Addendum No. 2

Twin Falls School District Harrison and Morningside HVAC

ADDENDUM NO. 02

Project Name: TFSD Harrison HVAC Replacement
Address: Twin Falls, Idaho

Sheet No:
A9.11

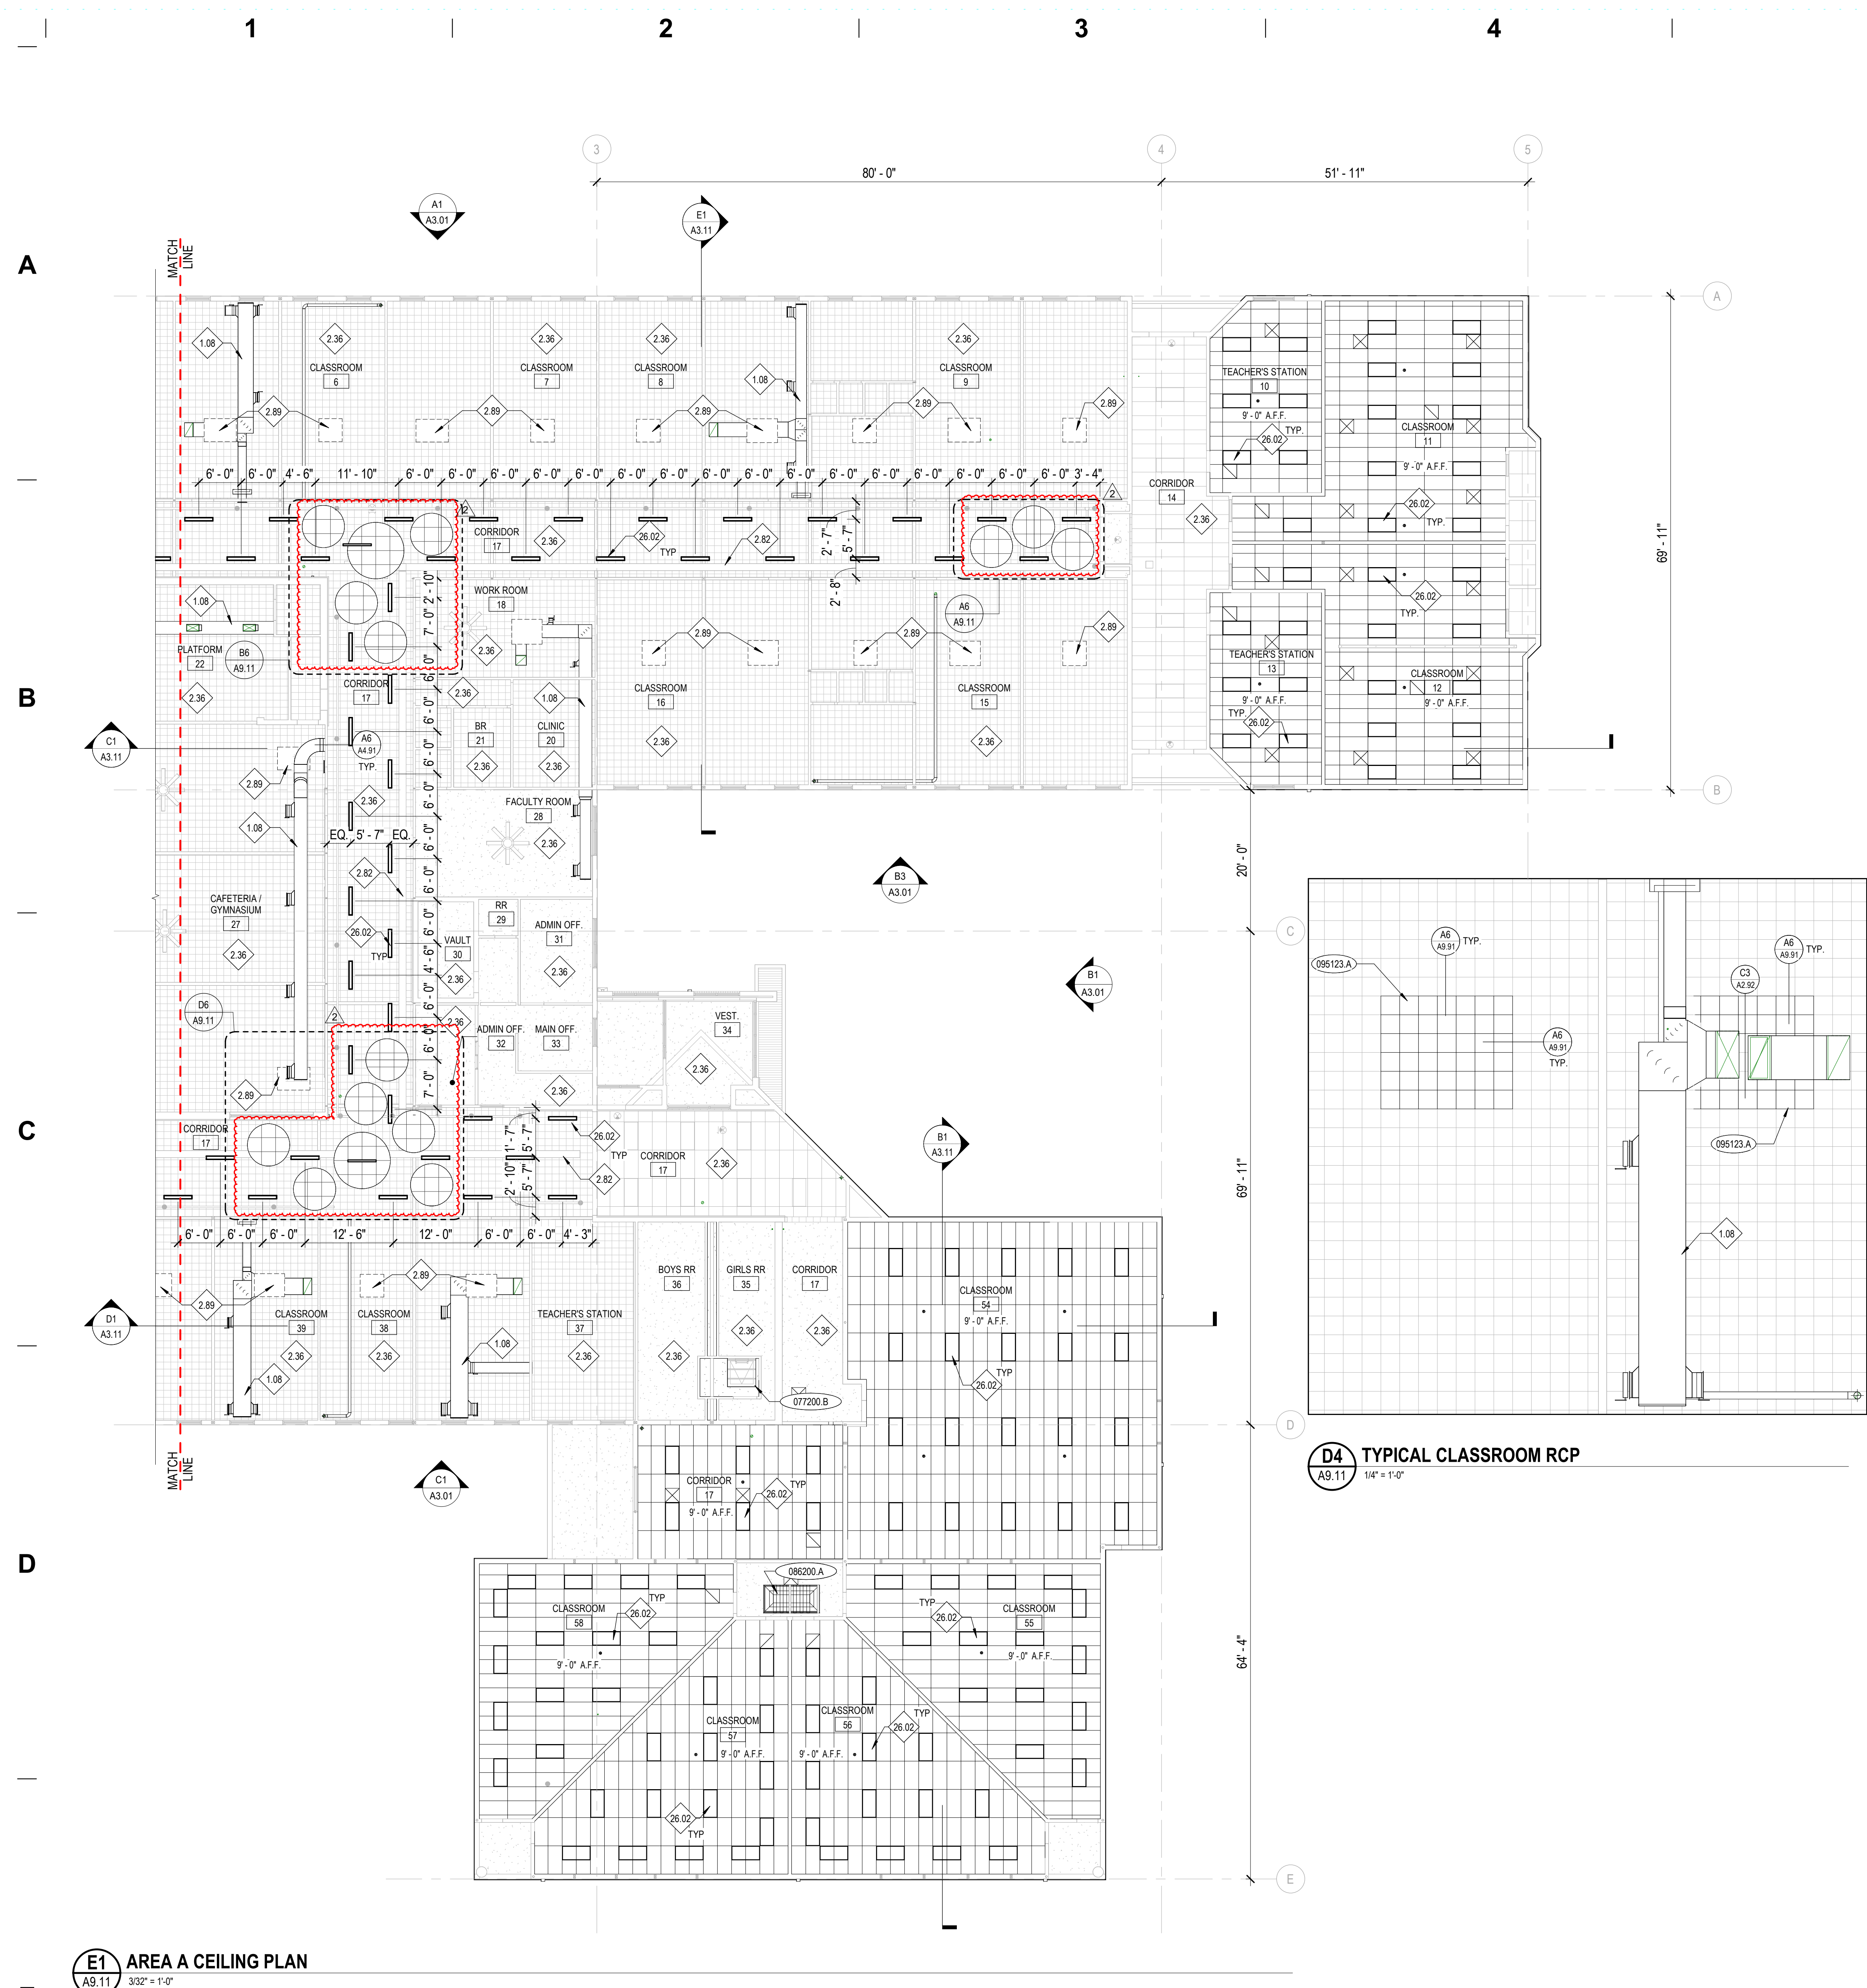
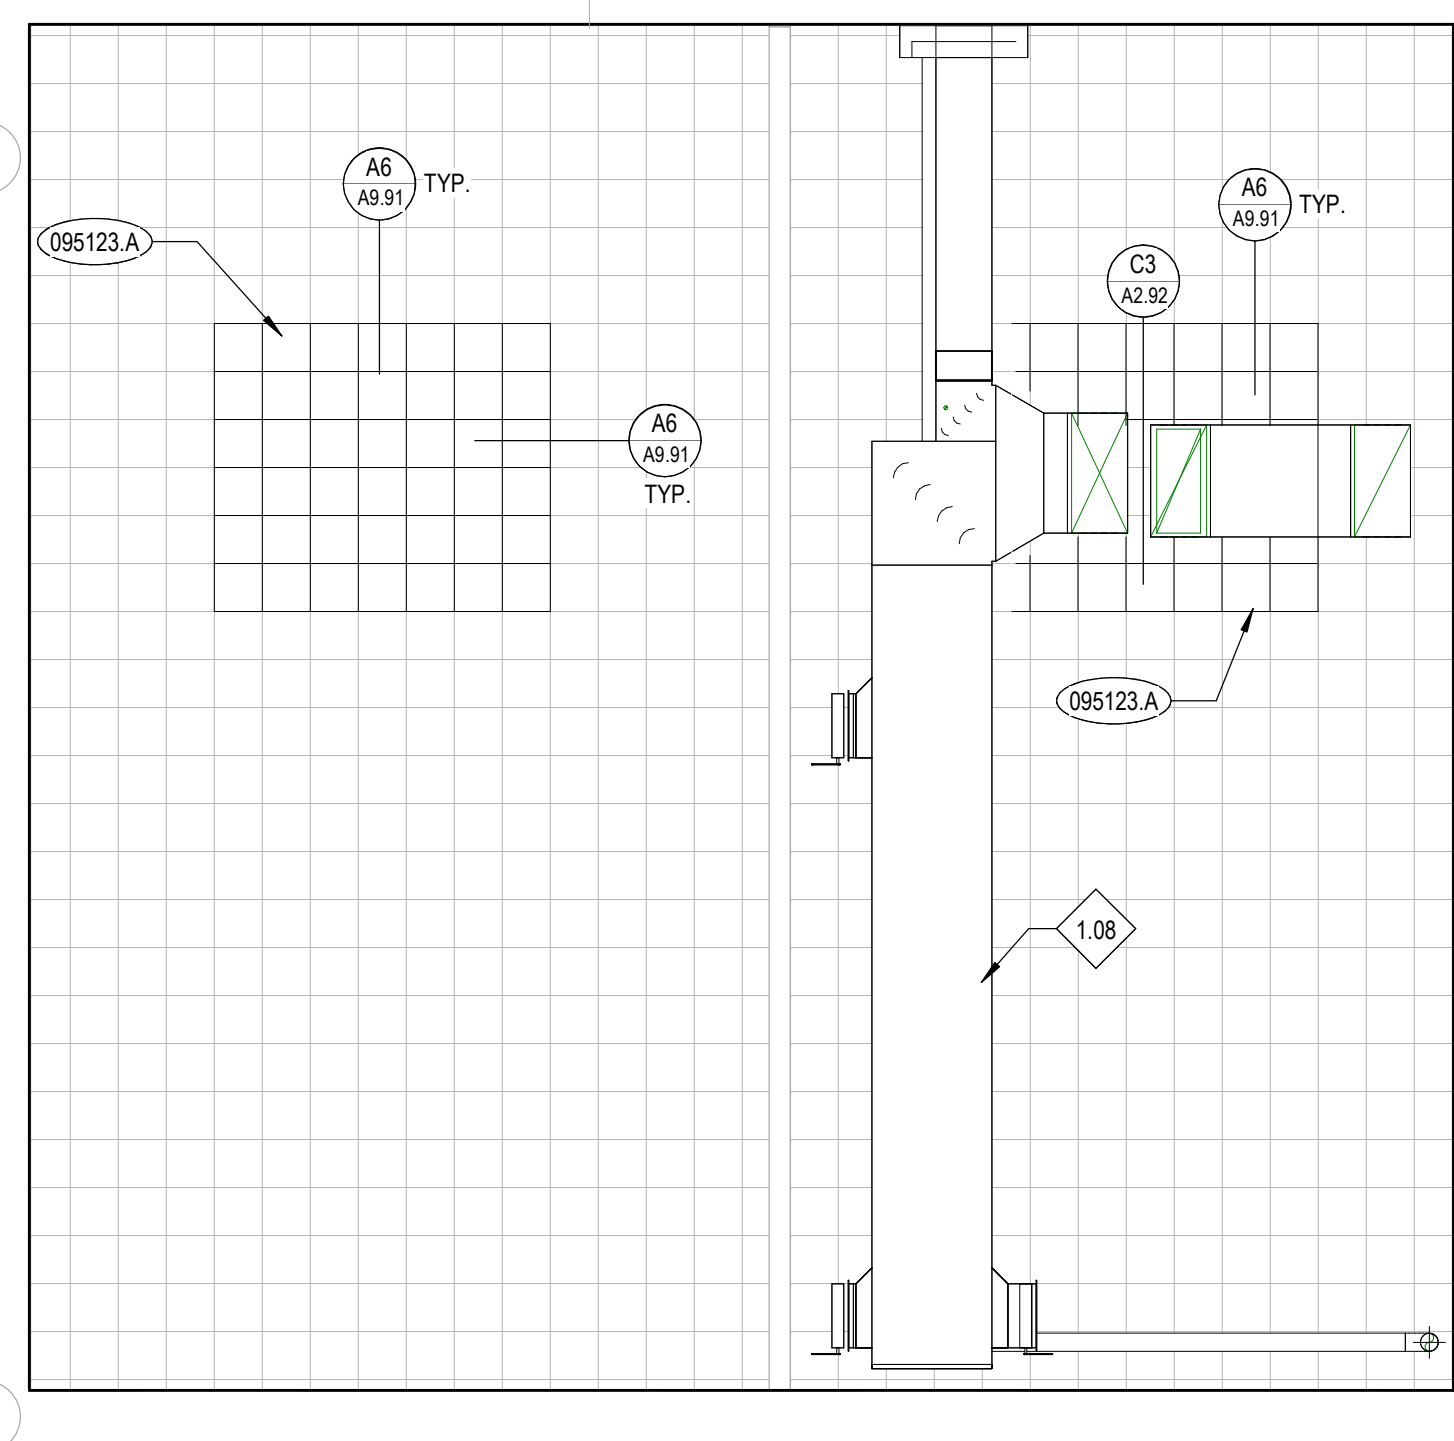
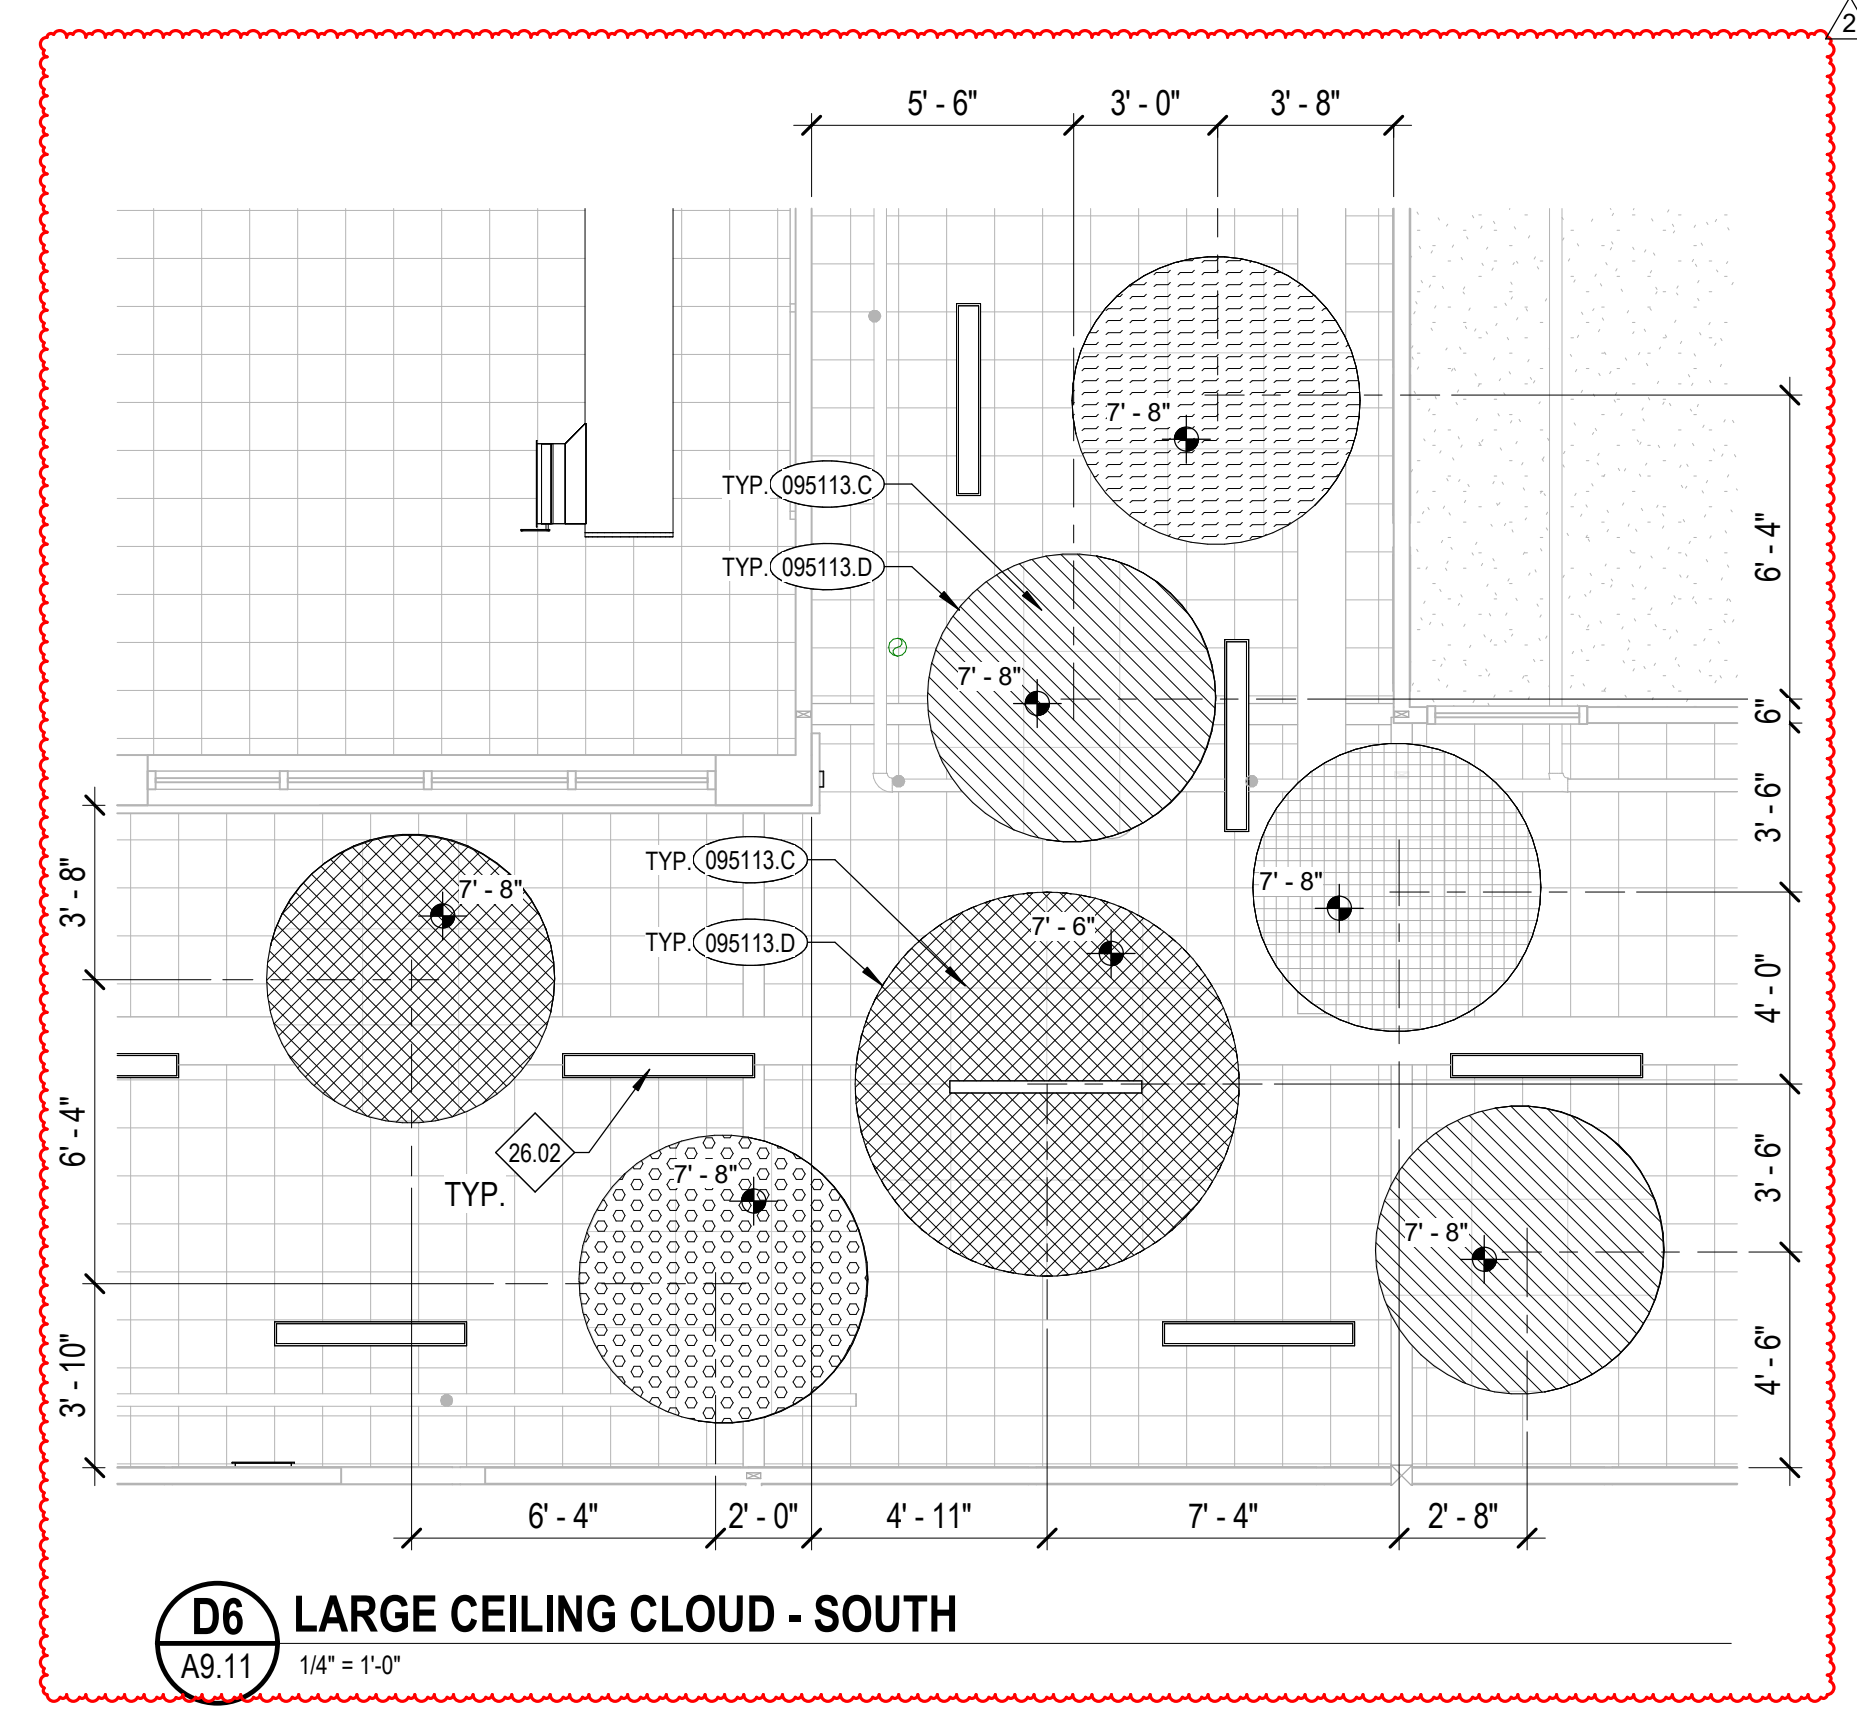
- **A9.01 – COMPOSITE CEILING PLAN**
 1. Change 4'-0" ceiling cloud to 6'-0" ceiling cloud
 2. Update ceiling grids from 2'-0" x 4'-0" grid to 2'-0" x 2'-0" grid.
- **A9.11 – AREA 'A' CEILING PLAN**
 1. Change 4'-0" ceiling cloud to 6'-0" ceiling cloud. Update dimensions and locations of ceiling clouds.
 2. Update ceiling grids from 2'-0" x 4'-0" grid to 2'-0" x 2'-0" grid.
- **A9.12- AREA 'B' CEILING PLAN**
 1. Change 4'-0" ceiling cloud to 6'-0" ceiling cloud. Update dimensions and locations of ceiling clouds.
 2. Update ceiling grids from 2'-0" x 4'-0" grid to 2'-0" x 2'-0" grid.
